Summary of Items Discussed in APSEC Discussion Forum (ADF) 3/2024 on 9 August 2024

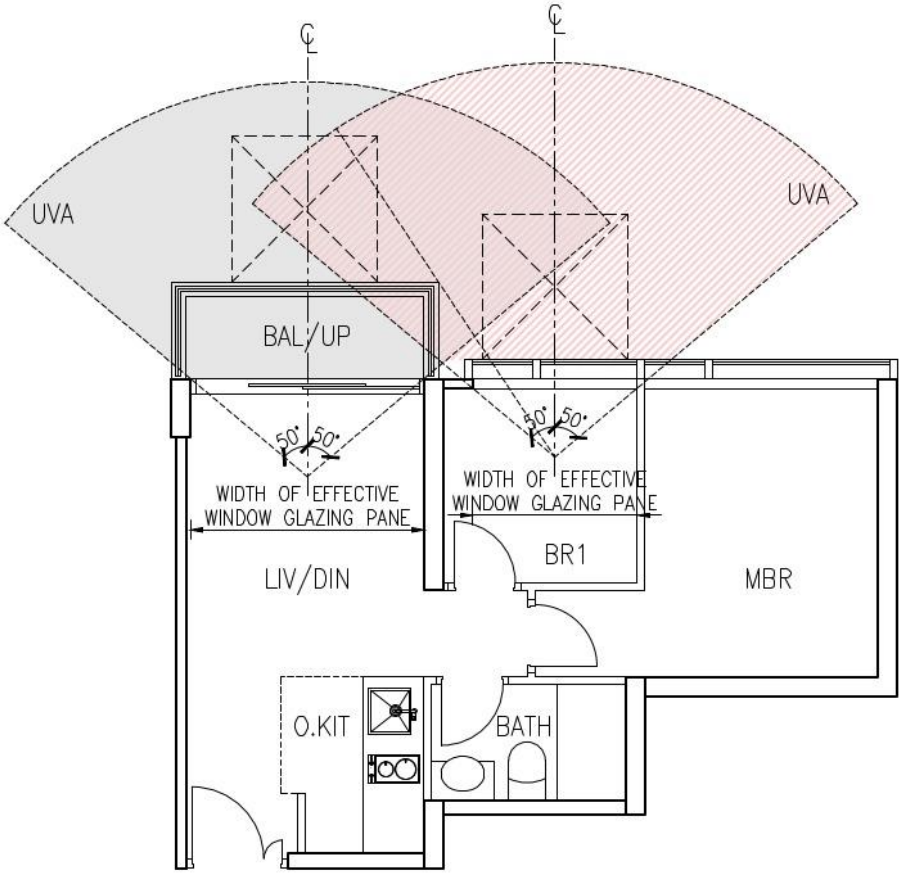
6.	<p><u>UVA encroaching on Balcony and Utility Platform (UP)</u></p> <p>It is our understanding that the window/door of the living/dining room facing</p>	<p>BD advised that HKIA's understanding was correct and the scenarios</p>

<p>the balcony/UP is considered satisfying the performance standards on the provision of natural lighting and ventilation for the purpose of regulations 30, 31 and 32 of the Building (Planning) Regulations by the unobstructed vision area (UVA) method under PNAP APP-130. By the same token, as illustrated in the below diagram, for the UVA of the adjacent room of the same unit, it is our understanding that the area of the UVA encroaching onto the balcony and UP can also be included into the UVA area calculation.</p> <p>Would BD please confirm if our understanding is correct or not.</p>	<p>depicted in the diagram were generally acceptable.</p> <p>In passing, BD advised that PNAP APP-130 was currently under review including the measurement of UVA in relation to projecting features such as balcony, UP and A/C platform.</p>
---	--

Vertical Greening

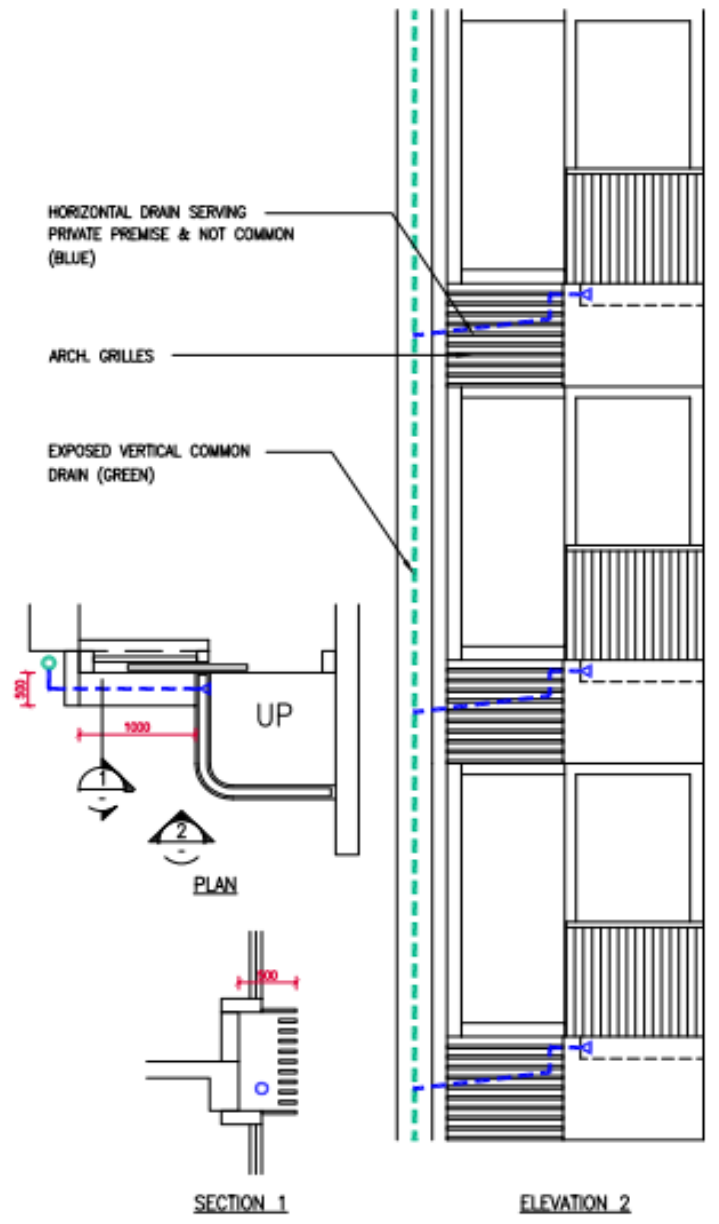
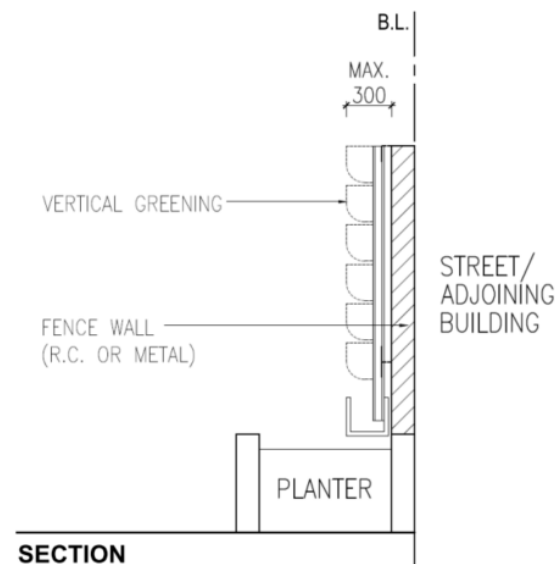
It is general practice that a boundary fence wall of reasonable height and thickness is not accountable for SC and GFA calculations.

Our understanding is that vertical greening (modular type/wire type) installed on a boundary fence wall in compliance with PNAP APP-152 or any additional provision for greening purposes shall be exempted from SC and GFA calculations, provided that the thickness of the vertical green wall system is reasonable and the modification of regulation 23(3)(a) of the Building (Planning) Regulations is granted by BD.

Would BD please advise if our understanding is correct or not.

BD advised that according to paragraph 3(n) of PNAP APP-19, metal supporting frames for growing of plants (including vertical frame for climbing and/or weeping plants and panel/modular planters) projecting not more than 300 mm from the external walls within lot boundary could be excluded from site coverage and plot ratio calculations under the Building (Planning) Regulations. The same principle was also applicable to similar metal supporting frames projecting from a fence wall.

Protective Barrier – PNAP APP-110

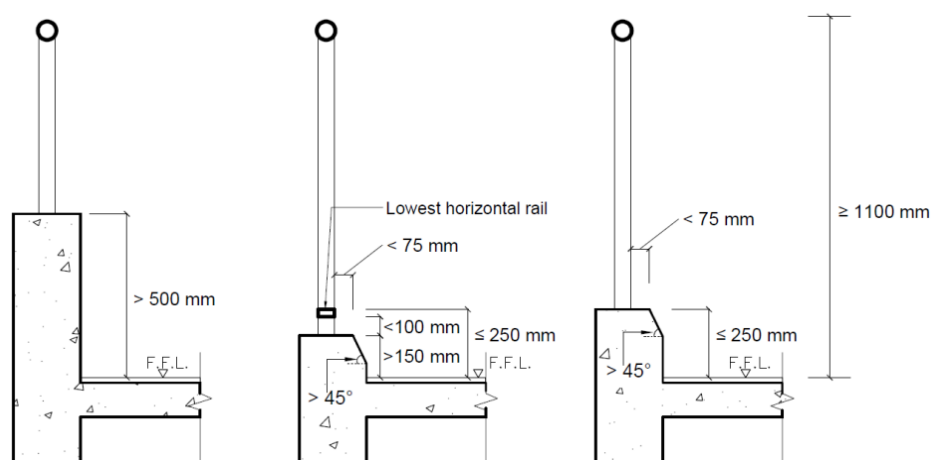
According to paragraph 3 of PNAP APP-110 issued in June 2024, if the bottom solid curb portion is less than 500 mm, the height of curb of railing type protective barrier must be not less than 150mm and not more than 250 mm above the adjoining floor level, as shown in the following illustrations extracted from Appendix A to the said PNAP, in order for the curb not to be regarded as an adjoining floor level.

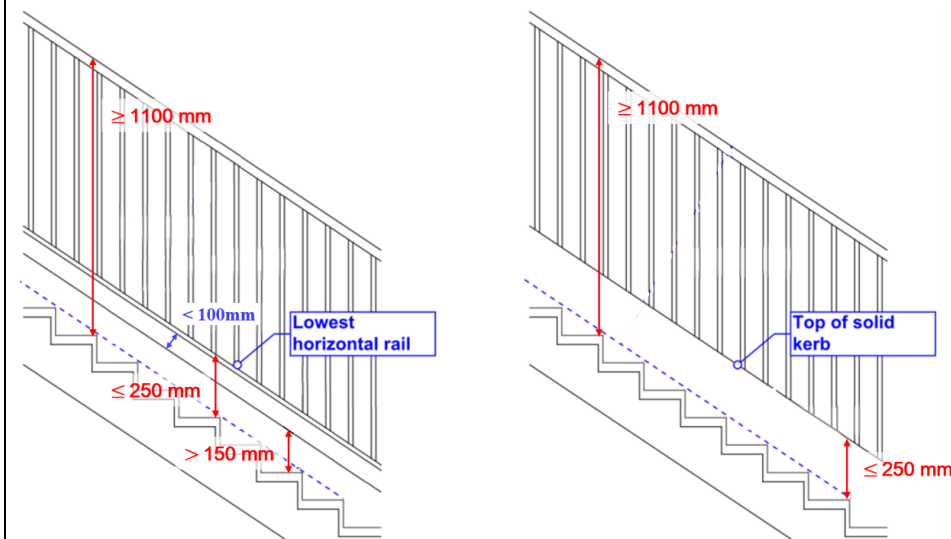
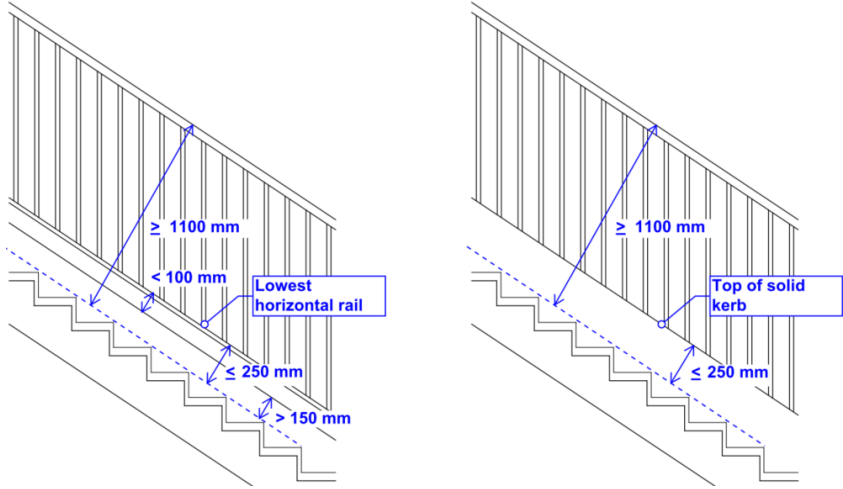
For staircases requiring a protective barrier, the measurement should be based on the diagrams below. Could BD please clarify if the HKIA's understanding is correct or not?

BD advised that the measurements should be taken in a vertical manner from the highest point of each tread to the top of the balustrade as illustrated in red in the diagrams below for fulfilling the requirements laid down in PNAP APP-110.

Figure 1 – Diagram showing wind directions and the relationship between the local axis and northing (N)

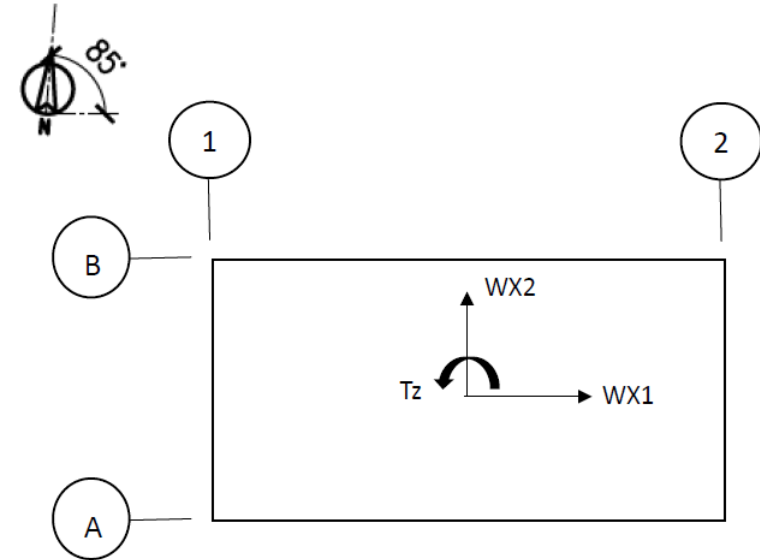
<p>However, BD confirmed that they would review the essential information of lateral wind load to be shown on structural plans for approval. Would BD please advise the outcome of their review.</p>	<p>approval:</p> <ul style="list-style-type: none">(a) a diagram showing the orthogonal wind directions of the subject building and the relationship between the building local axis and actual northing (N);(b) the height of building (H), the wind reference pressures or design wind loads of each wind directions at the topmost level with the corresponding effective height (Z_e);(c) directionality factors (S_θ);(d) topographic multipliers (S_t);(e) force coefficient (C_f); and(f) size and dynamic factors ($S_{q,z}$). <p>Illustrative examples were shown below for reference:</p>
--	--

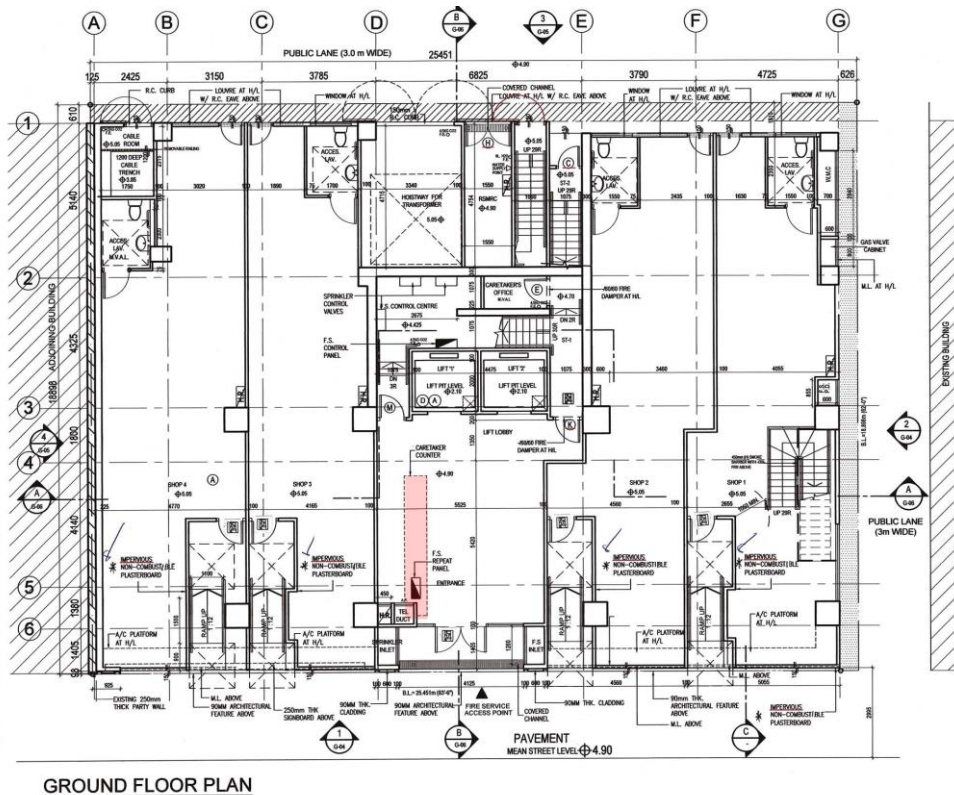
0.84	0.85	0.85	0.84																															
	Items raised by AAP																																	
20.	<p><u>Caretaker Counter at the Access to Fireman’s Lift at Ground Floor</u></p> <p>To revisit item 17 of ADF 4/2023 held on 17 November 2023, it is a usual practice that a caretaker counter at G/F lobby can open directly to the passage from the fire service access point (FSAP) to the fireman’s lift as illustrated in plan below and is acceptable to BD. Please confirm if such understanding is correct.</p>	<p>BD advised that the arrangement depicted in the diagram generally complied with Clause B9.1 of the FS Code. As regards Clause D7.3(b), the case would be favourably considered subject to no objection from FSD.</p>

Figure 1 - Typical detail for soldier pile wall to be used as permanent cantilever wall (using interlocking pipe pile)

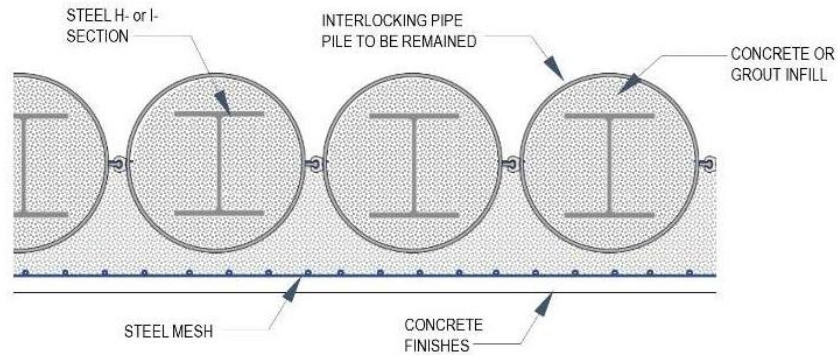
26.	<p><u>Corrosion Protection Measures of Permanent Soldier Piles</u></p> <p>Please advise if the corrosion protection measures on permanent soldier piles shown in Figures 1 to 3 below are acceptable and hence no sacrificing thickness on the soldier piles is required if such protection measures are adopted.</p>	BD advised that the issue was being reviewed by BD and GEO.

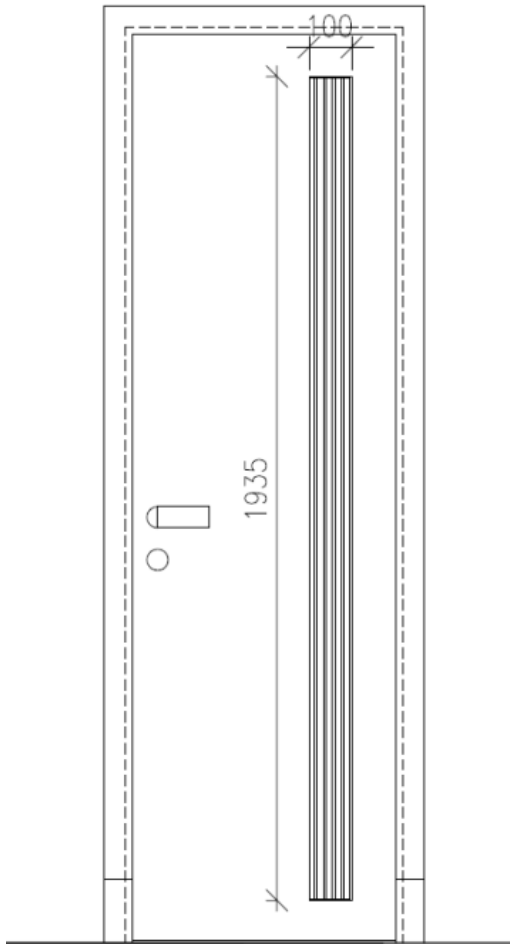
Would BD please confirm if the understanding is correct?	
	AOB Items	
28.	<p><u>Aperture protected with Ventilating Louvres for Internal Bathroom</u> (Item raised by AAP)</p> <p>According to paragraph 3(b) of PNAP APP-98, permanent ventilation in the form of an aperture in a door, which should be suitably located and protected with louvres having a minimum size of 1/20 of the floor area of the room is acceptable. As such, would BD please confirm that the size of the aperture protected with louvres as shown in below sketch is acceptable:</p>	<p>BD advised that AAP's proposed provision of louvre for compliance with the requirements in paragraph 3(b) of PNAP APP-98 was acceptable.</p>

Room Area = 3.85 sq.m

Minimum required size of aperture protected with louvres
= 3.85 sq.m / 20 = 0.1925 sq.m

Louvre Area = 1.935m x 0.1m = 0.1935 sq.m > 0.1925 sq.m (required)	
29.	<p><u>Insulation for Fire Dampers</u> (Item raised by AAP)</p> <p>According to Table C2 of the FS Code,</p> <ul style="list-style-type: none"> • fire dampers should have an fire resistance rating (FRR) with regard to the criterion of integrity only, the criterion of insulation is not required for fire dampers <u>unless specified</u>; and • fire barriers should have an FRR with regard to the criterion of both integrity and insulation <p>According to Clause C8.2 of the FS Code, building services passing through a fire barrier should be protected with fire dampers or other suitable form of fire stop to maintain the required FRR of that fire barrier.</p> <p>In Hong Kong, there are very limited suppliers providing fire dampers with insulation. In BD's Central Data Bank, there are a few kinds of fire dampers with 240 minutes integrity but not insulation.</p> <p>As such, would BD please advise, for building services passing through a fire barrier with fire damper, whether such fire damper needs to satisfy the insulation criterion of FRR.</p>	<p>BD advised that under Clause C4.2 and item 9 in Table C2 of the FS Code, the criterion of insulation was not applicable to fire dampers unless specified otherwise. Accordingly, the criterion of insulation was not applicable to the fire dampers specified in Clause C8.2.</p>
